City of Cranston  
**City Plan Commission**

# “West Arlington Replat of Lots 391, 392, 393, 394, 434, 435, and 436”

Preliminary Plan, Minor Subdivision without street extension – Associated 3 Variance Requests

# SITE PLAN

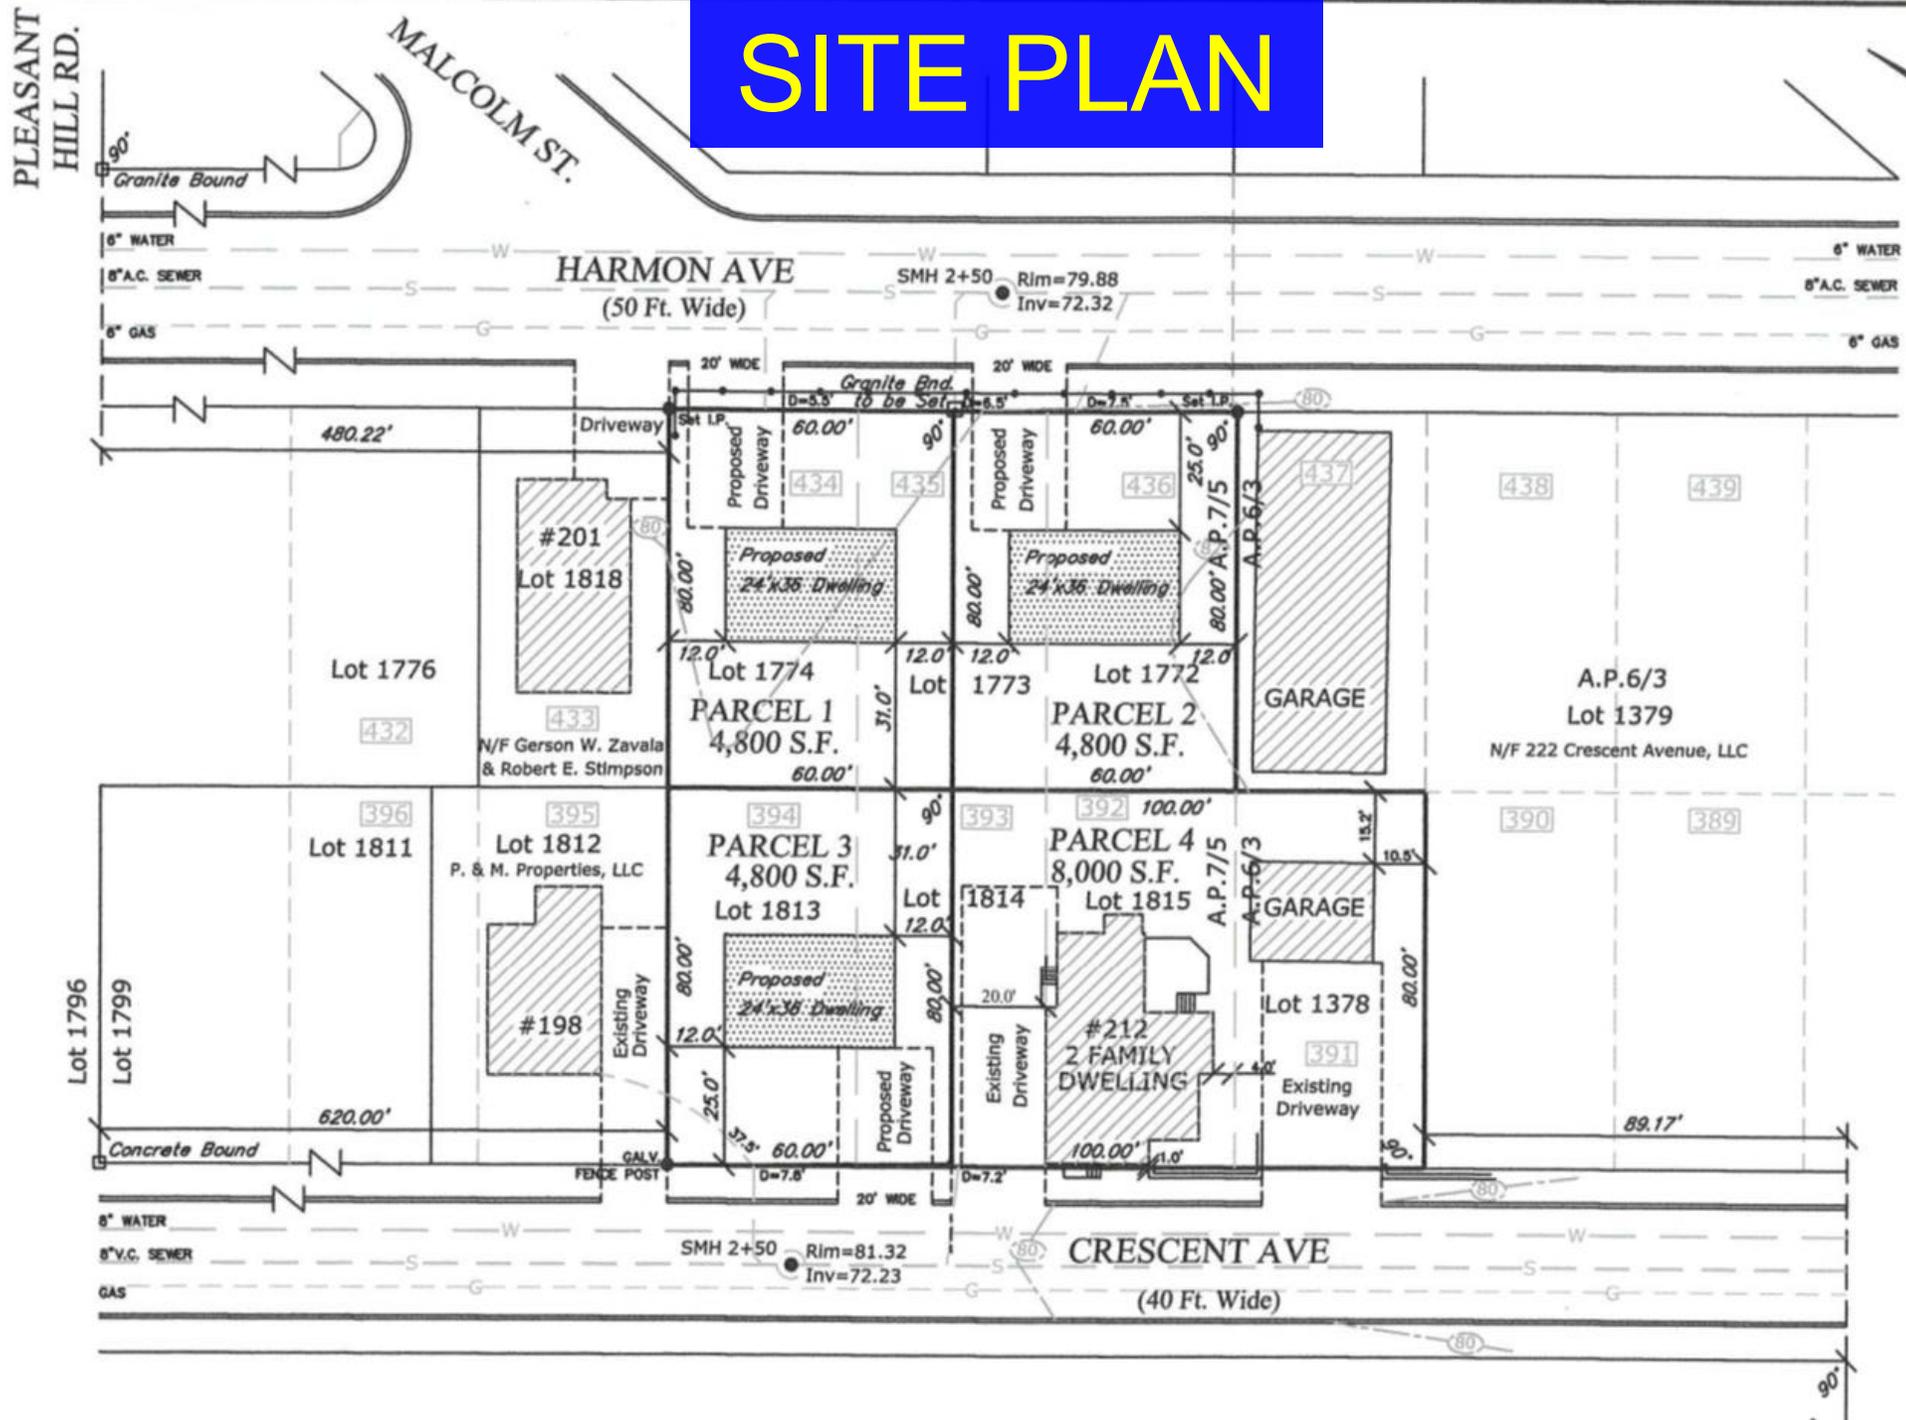
- The applicant proposes to subdivide/merge a total of 7 existing lots into 4 proposed new lots that will be larger in size. The project proposes 3 lots that will each be 4,800 sq. ft. for future single-family houses (requires ZBR approval), and 1 lot that will be 8,000 sq. ft. with a pre-existing, nonconforming two-family dwelling (no ZBR approval needed).

- The average size of residential lots within 400 feet of the subject parcels is 4,225 sq. ft., which is less than the proposed 3 substandard parcels (4,800 sq. ft.).

3. Three (3) of the proposed lots will require zoning relief for substandard lot size (proposed 4,800 ft<sup>2</sup> lots where 6,000 ft<sup>2</sup> is required). Should approval be granted through a separate decision by the Zoning Board of Review, the project will be in compliance with the City's zoning ordinance.

4. The proposal will not alter the general character of the surrounding area or impair the intent or purpose of the Cranston Zoning Code.
5. Clearing of vegetation (trees and bushes) would be needed in order to accommodate the development of new structures on proposed Parcels 1 and 2, however, the vegetation is not significant in size, does not provide environmental habitat, and is located within a dense urban neighborhood. Additionally, the project will be subject to all local, state and federal standards regarding environmental impacts. Thus no negative environmental impacts are anticipated.

1. Applicant shall receive variance approval for substandard lot area from the Cranston Zoning Board of Review prior to filing the Final Plan Application with the Cranston Planning Department.
2. Payment of the Eastern Cranston Capital Facilities impact fee in the amount of \$1,780.38 (3 new units) must be submitted at the time of final plat recording.
